# METROPOLITAN GOVERNMENT OF NASHVILLE AND DAVIDSON COUNTY

## STAFF RECOMMENDATION 4000 Cambridge Avenue October 15, 2014

**Application:** New construction—addition; Setback determination.  
**District:** Cherokee Park Neighborhood Conservation Zoning Overlay  
**Council District:** 24  
**Map and Parcel Number:** 10308019000  
**Applicant:** Charles Richardson  
**Project Lead:** Melissa Baldock, melissa.baldock@nashville.gov

CAMBRIDGE AVE.  
SITE PLAN

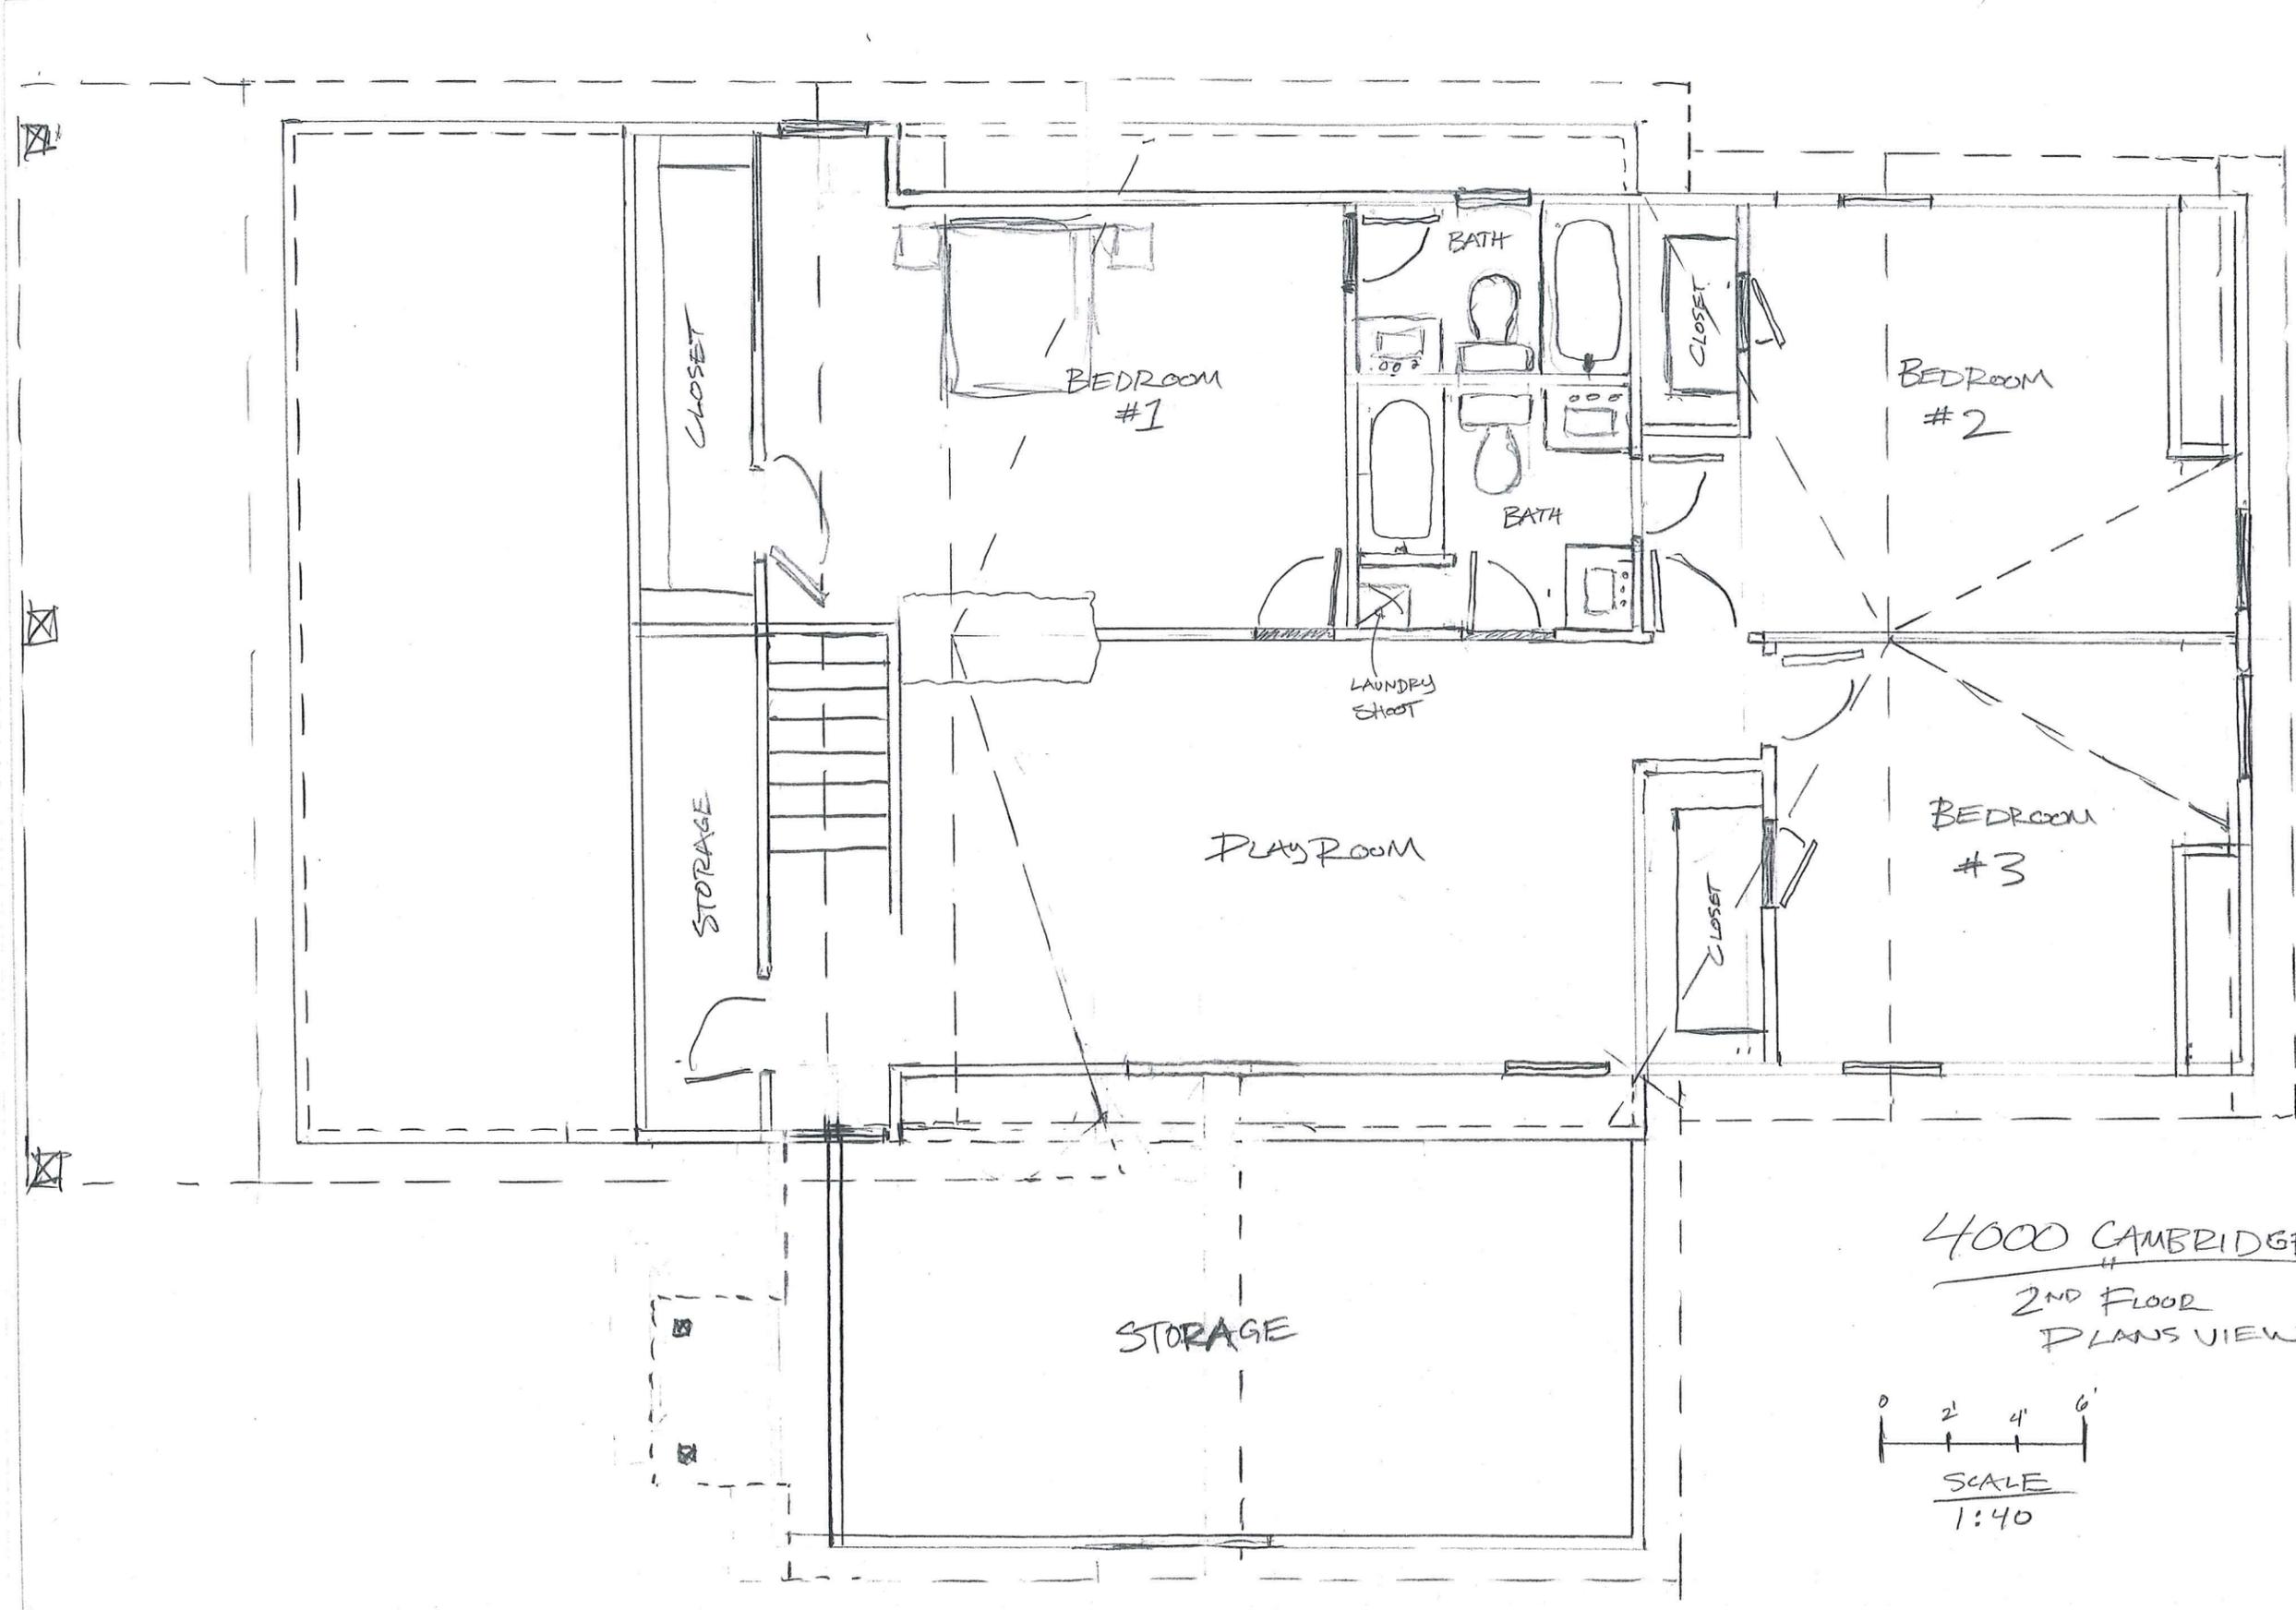
Setback & Rhythm of Spacing: 4000 Cambridge Avenue is an usually shaped lot. The original property, before subdivision, was triangular in shape due to the railroad running behind the property at an angle. Once the lot was subdivided into three parcels in the 1960s, 4000 Cambridge became wider but shallower than typical lots in the Cherokee Park neighborhood. The rear and side addition meet the base zoning setbacks for side property lines, but the rear addition does not meet the base zoning rear setback. Base zoning requires that a new addition be a minimum of twenty feet (20') from the rear of the property. However, the proposed rear addition will be just eleven feet (11') at its narrowest point from the rear property line. Staff finds the proposed rear setback to be appropriate in this instance because of the unusual shallowness of the lot and because the rear addition will still be more than forty feet (40') from the nearest corner of the house behind it.

Staff finds that the addition's setback and rhythm of spacing meet Sections II.B.1.c. and II.B.2. of the *Cherokee Park Neighborhood Conservation Zoning Overlay: Handbook and Design Guidelines*.

FRONT ELEVATION

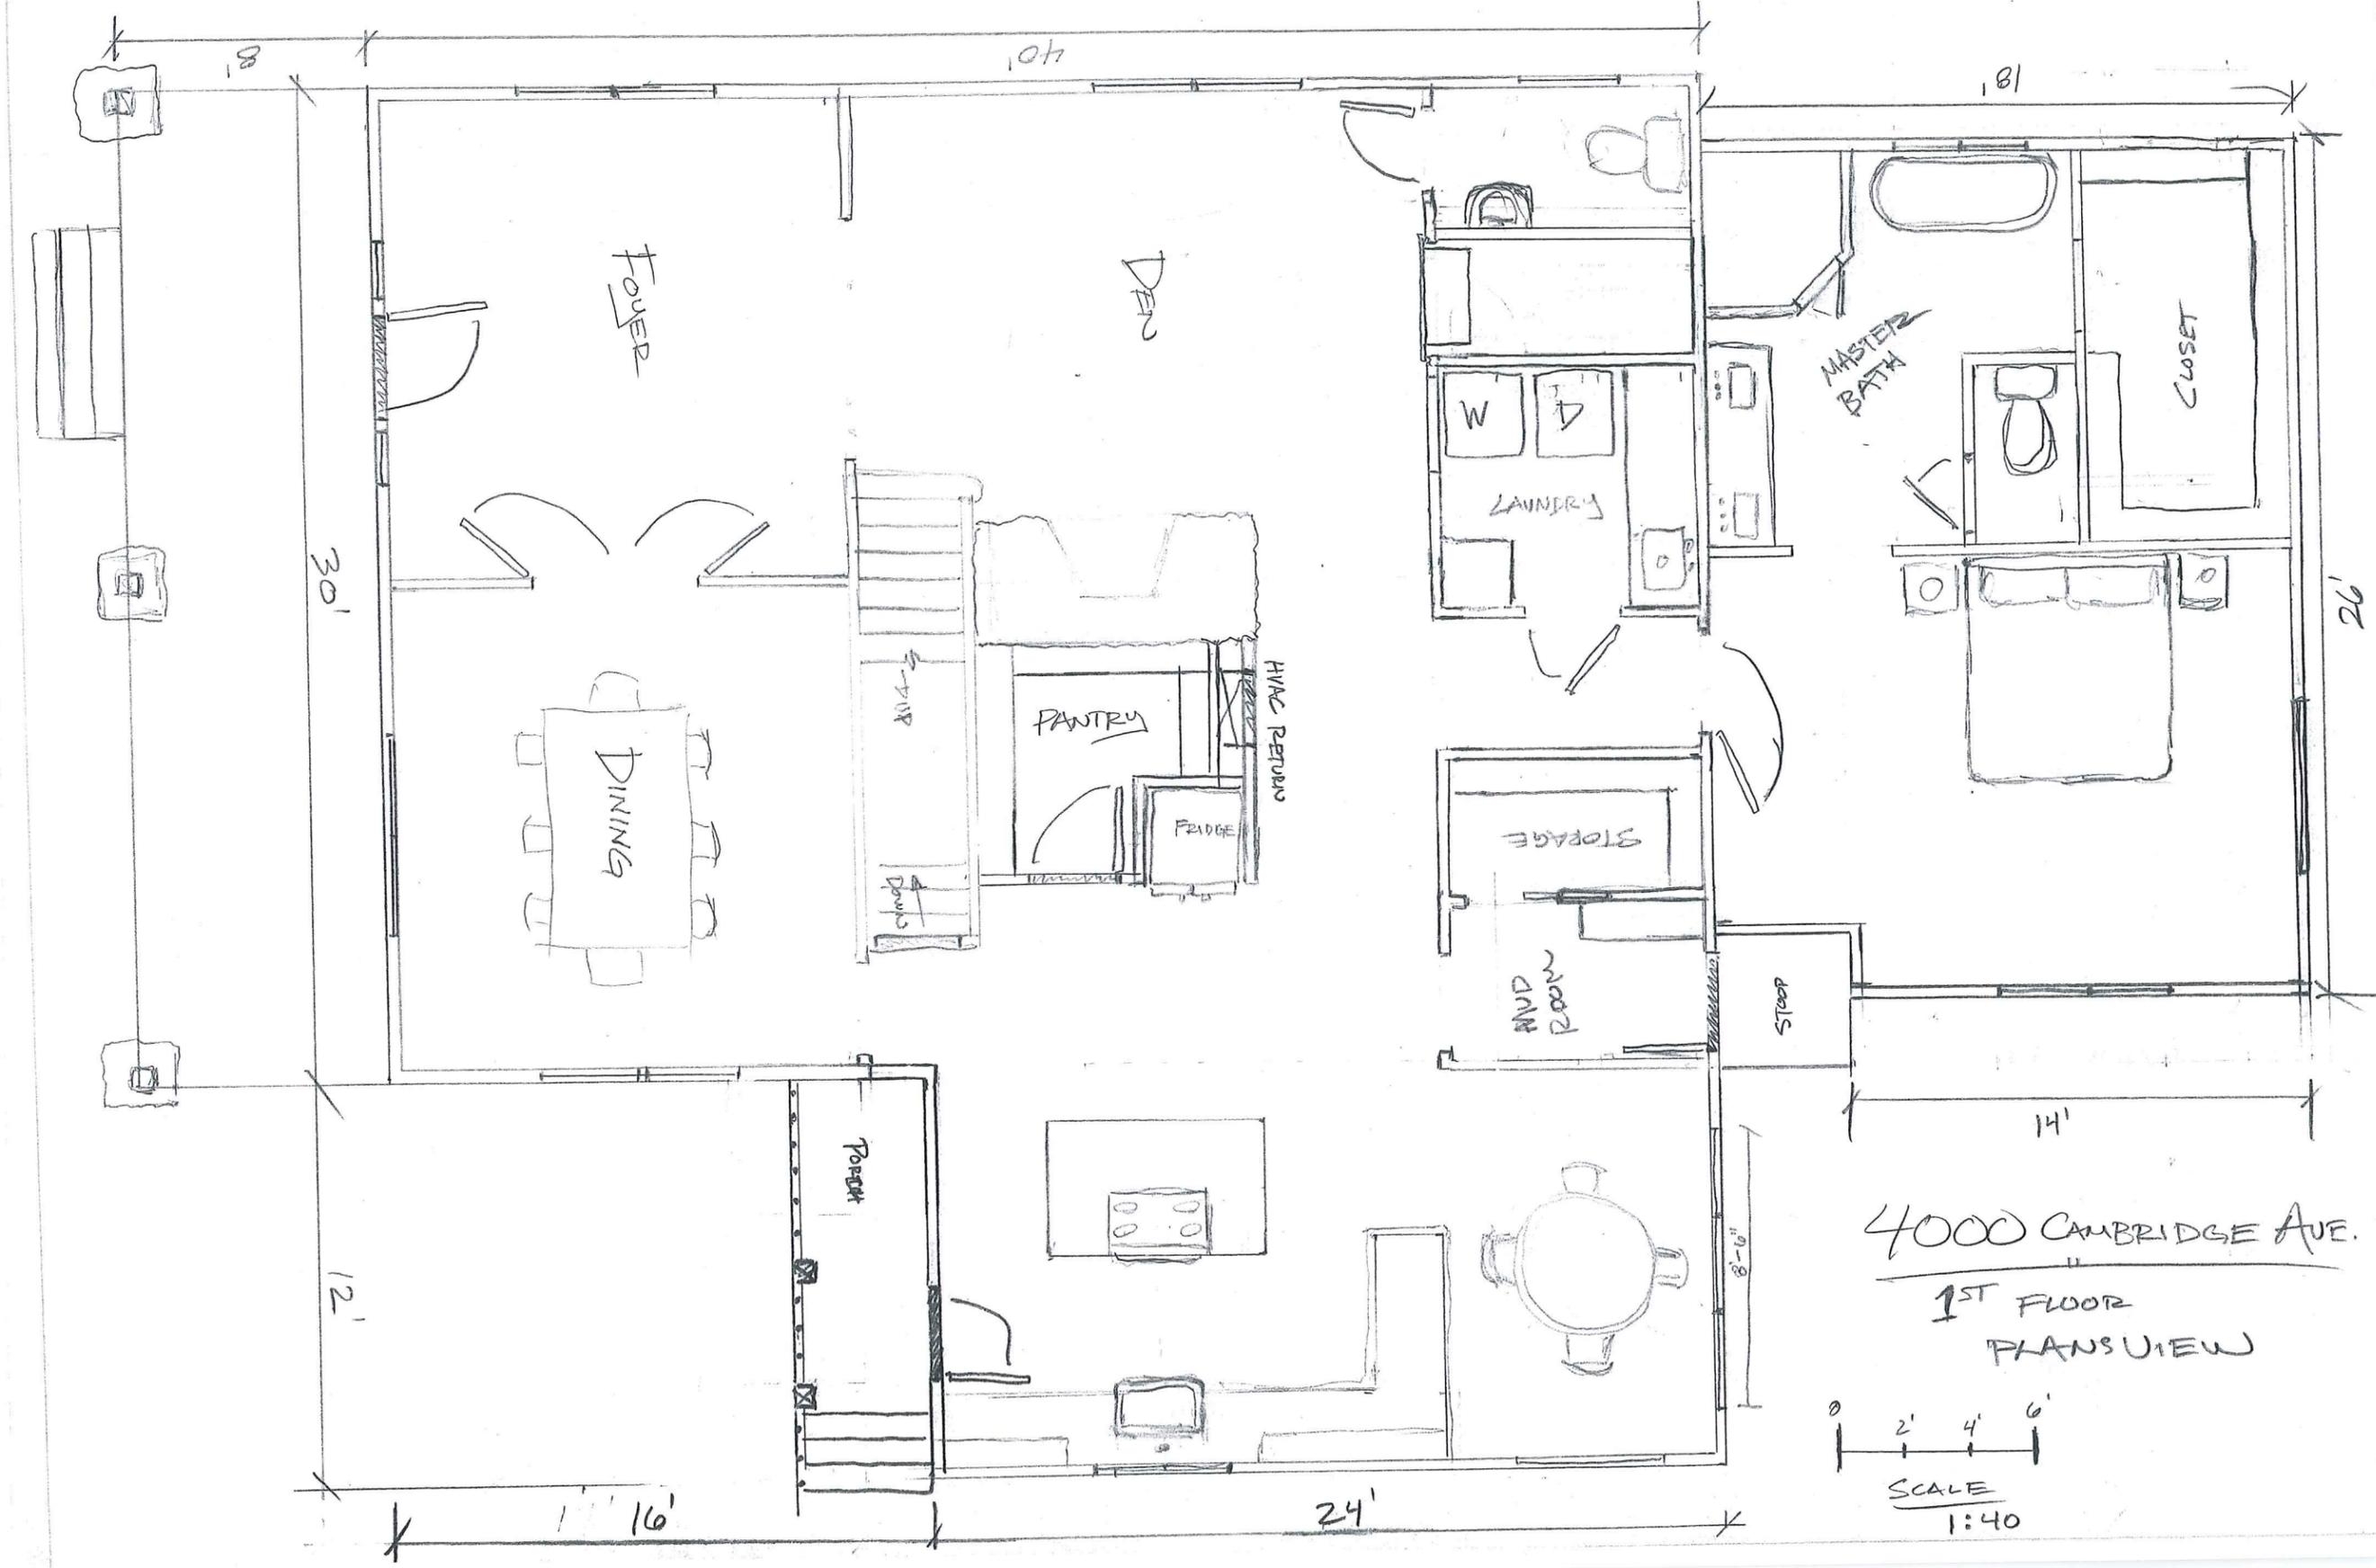
Roof form: The historic house has a side gabled roof form with a slope of 6/12. The proposed ridge raise will increase the height of the roof by two vertical feet (2') but will not alter its pitch. Staff notes that the side facades show that the ridge raise will go up two feet (2'), but the front façade indicates a ridge raise of approximately four feet (4'). Staff asks that a condition of approval be that the front façade drawing be revised to show a ridge raise of no more than two feet (2'). The rear addition will have a gabled roof with a slope of 9/12, and it incorporates both shed and rear dormers. The side addition will have a side gable roof form with a slope of 6/12 to match that of the historic house. Staff finds that the addition's roof forms meet Sections II.B.1.e. and II.B.2. of the *Cherokee Park Neighborhood Conservation Zoning Overlay: Handbook and Design Guidelines*.

1. Staff approve the shingle color and the final details, dimensions and materials of new doors prior to purchase and installation;
2. The applicant submit a revised front façade showing a ridge raise of no more than two feet (2'); and
3. The HVAC shall be located behind the house or on either side, beyond the midpoint of the house.
